WATERBURY FILING NO. 1 EL PASO COUNTY, CO CONSTRUCTION SET FEBRUARY 2023

EPC STORMWATER REVIEW COMMENTS IN ORANGE BOXES WITH BLACK TEXT

**PERMANENT FOREBAY DETAIL**  
SCALE: 1"=5'

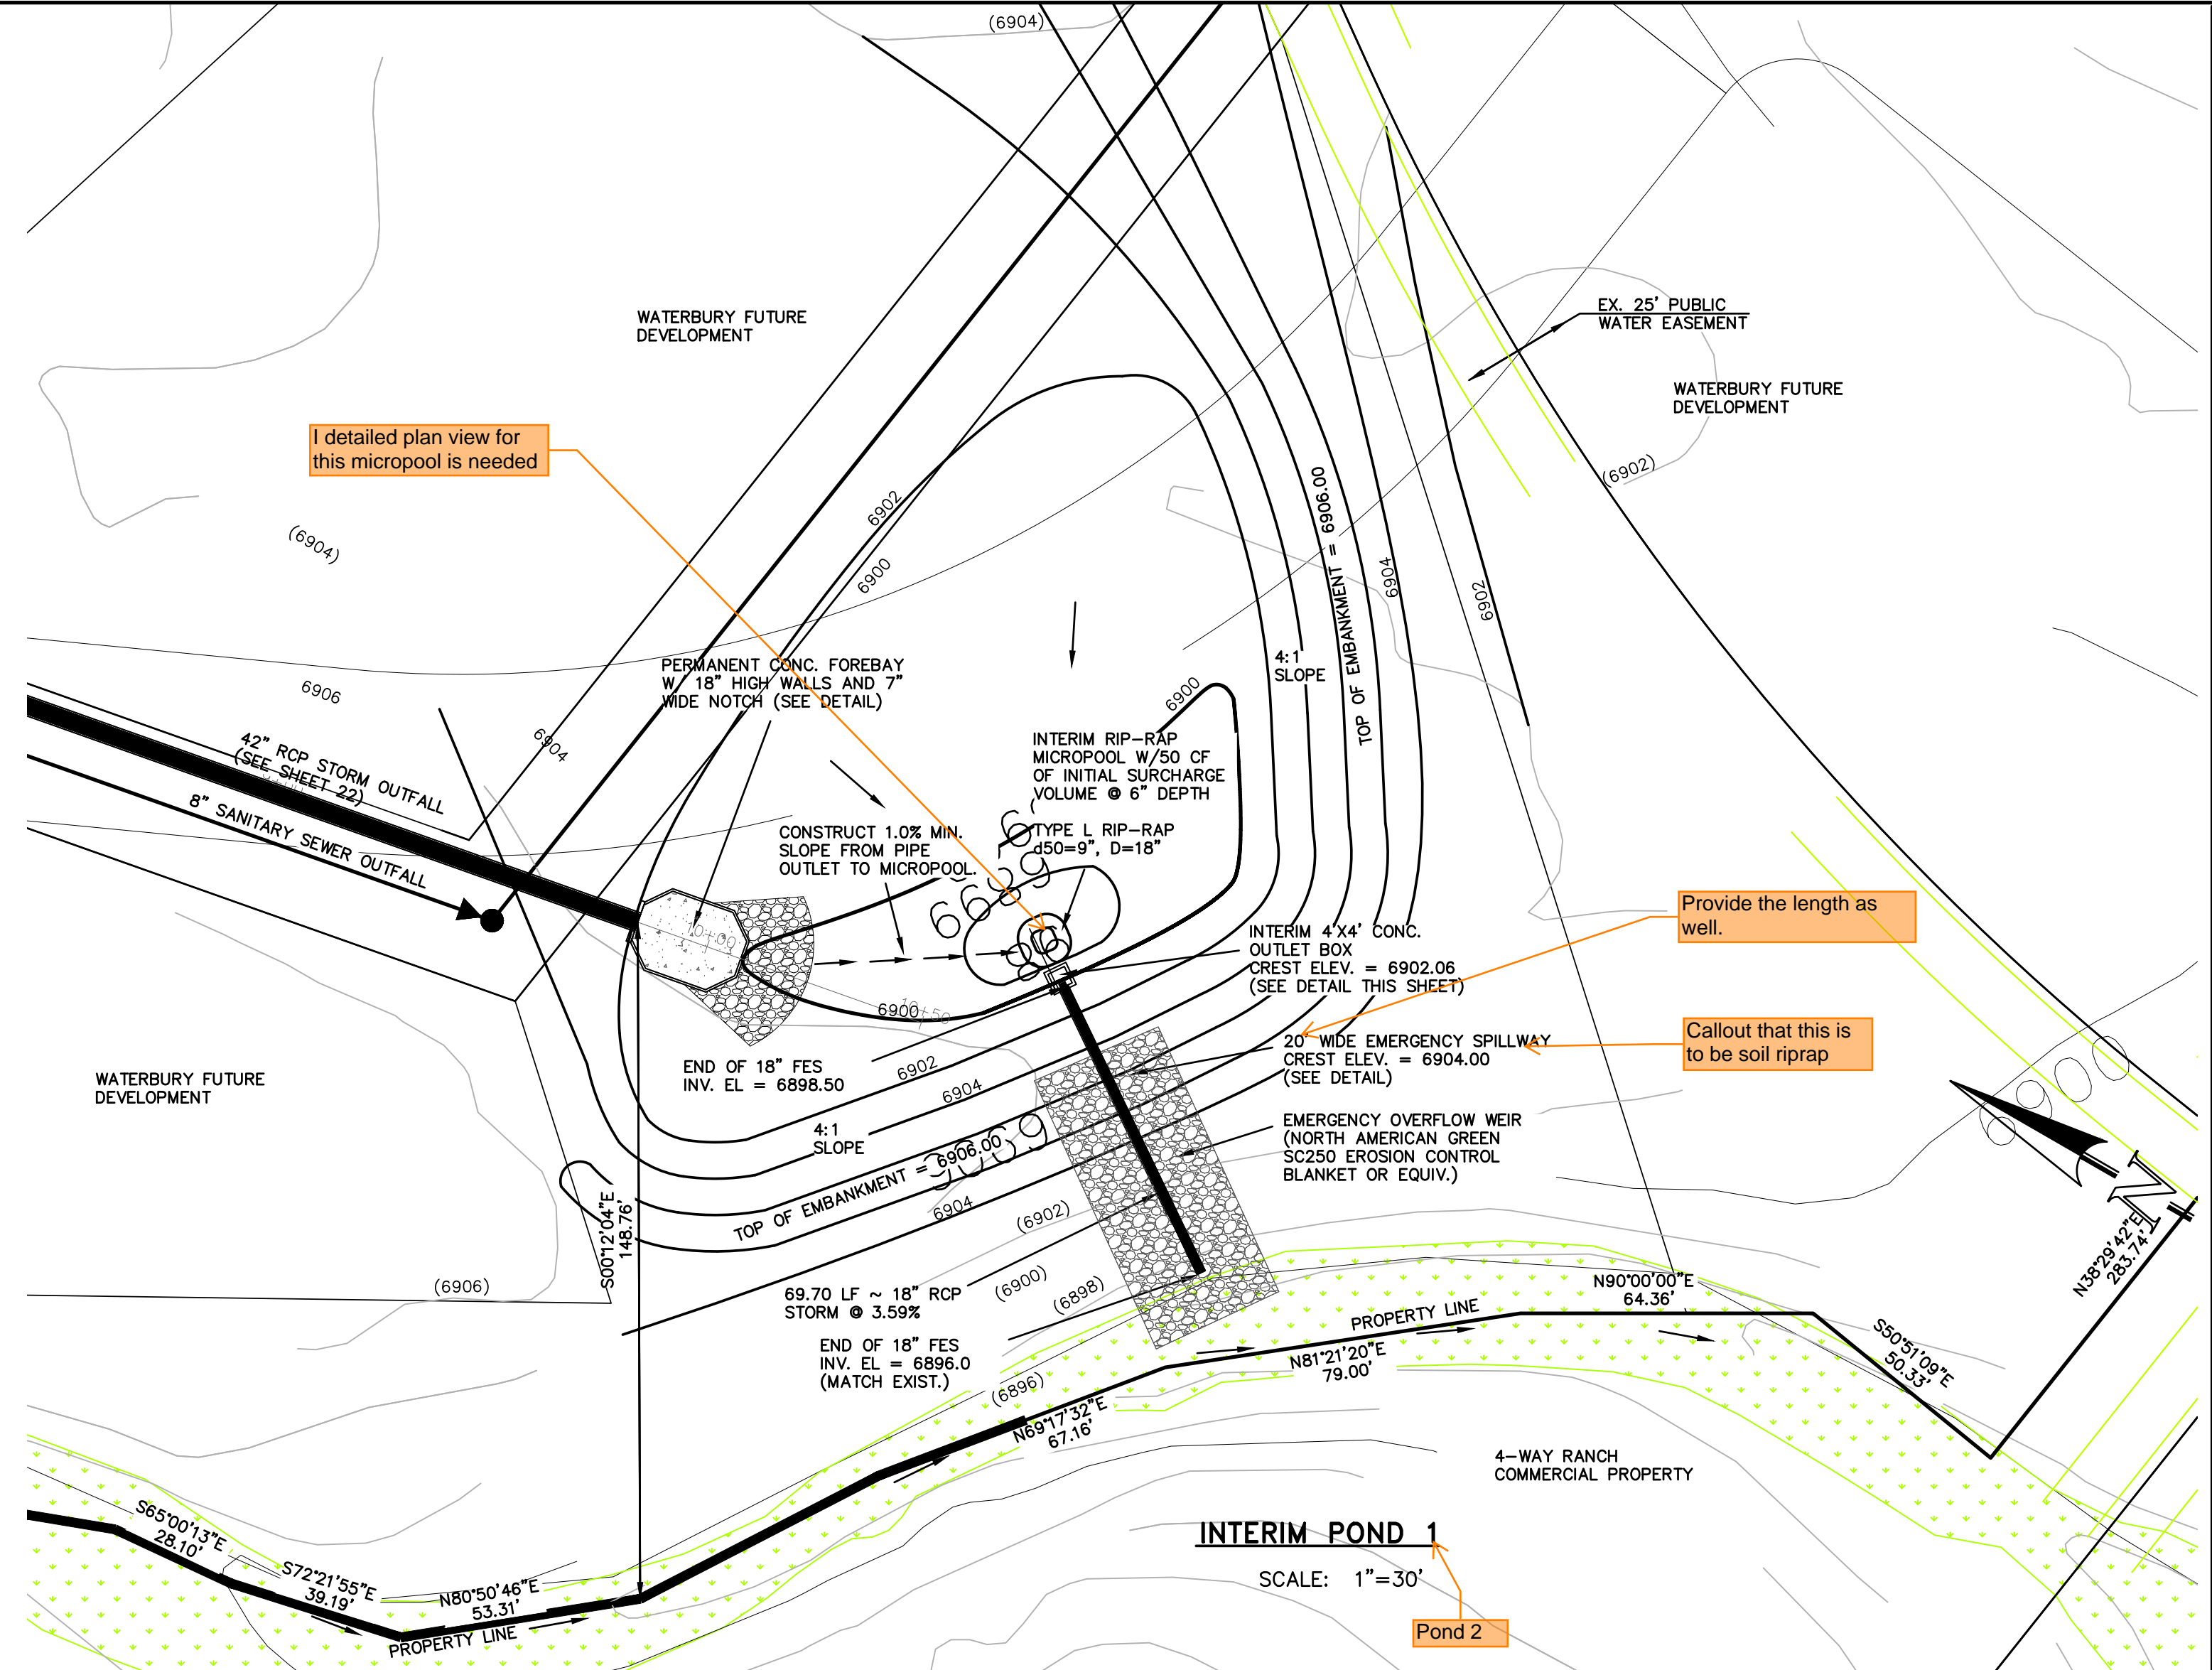
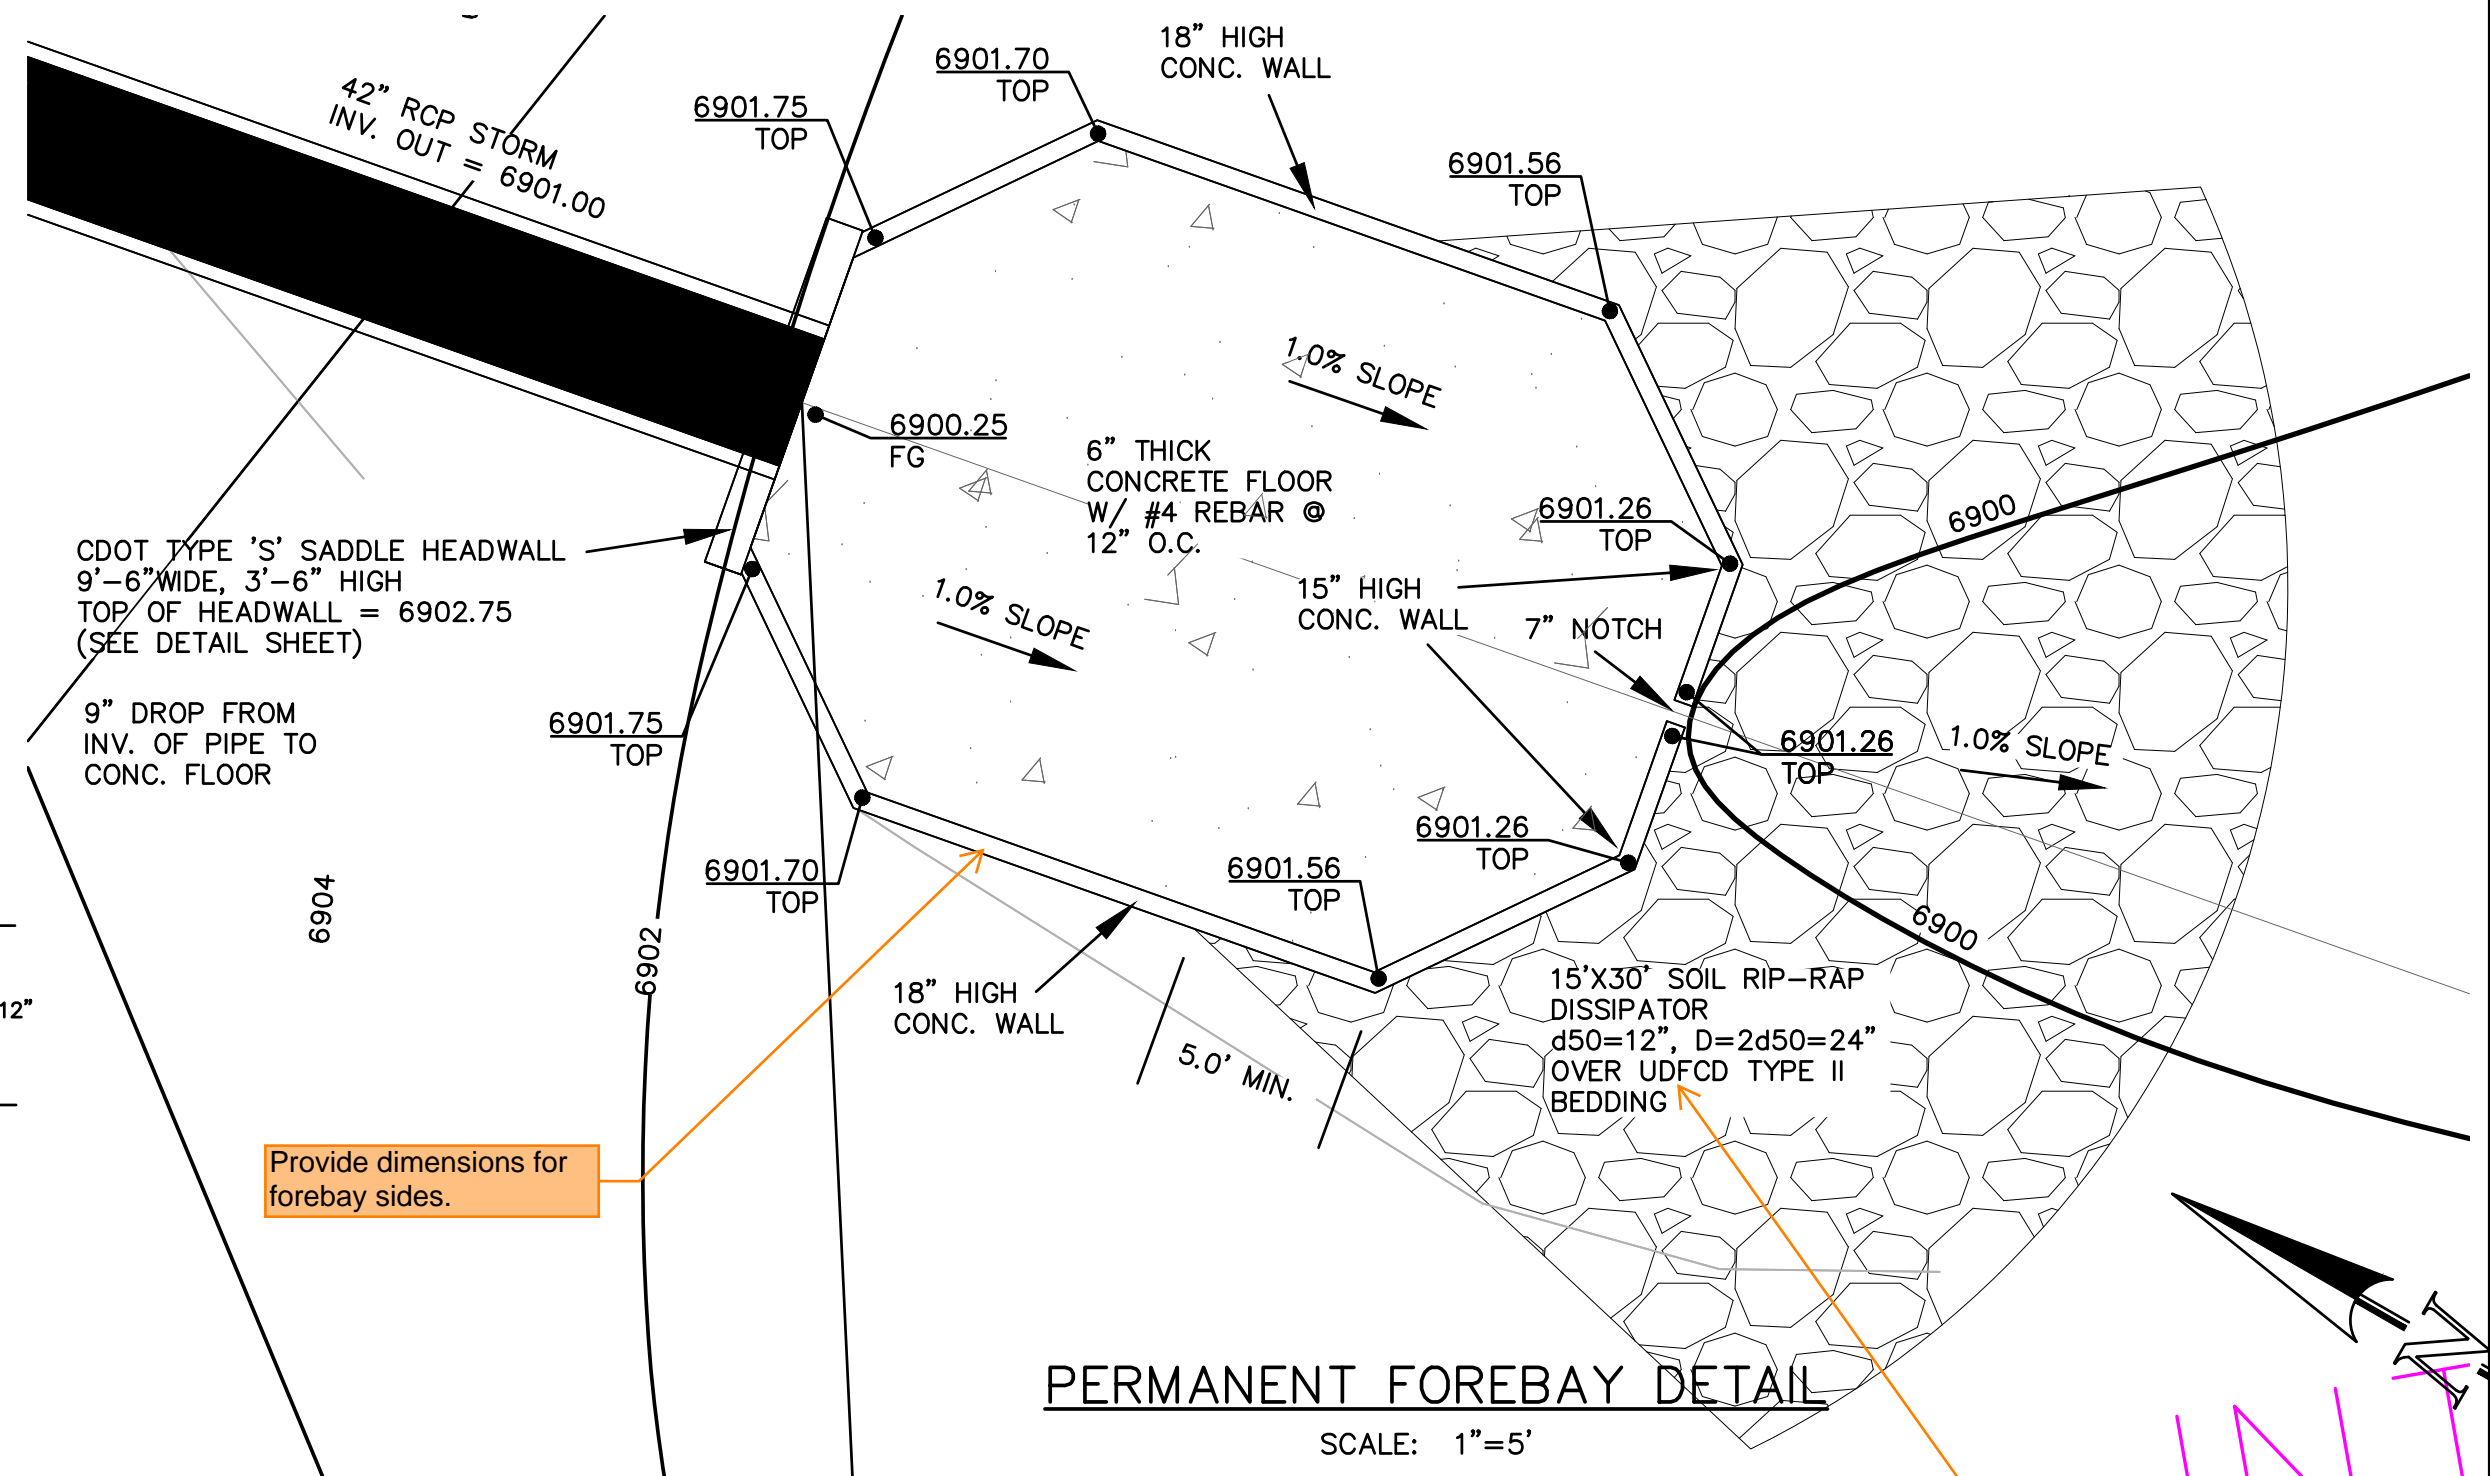
Just for reference, MHFD detail T-5 states:  
\* The bottom should be concrete unless a baseflow is present or anticipated or if groundwater is anticipated. Riprap is not recommended because it complicates maintenance operations.

Does not match detail below or what is shown in DR calcs. Revise to remove discrepancy.

Value does not match DR spreadsheet. Verify and update so both match.

Values do not match DR spreadsheet. Verify and update so both match.
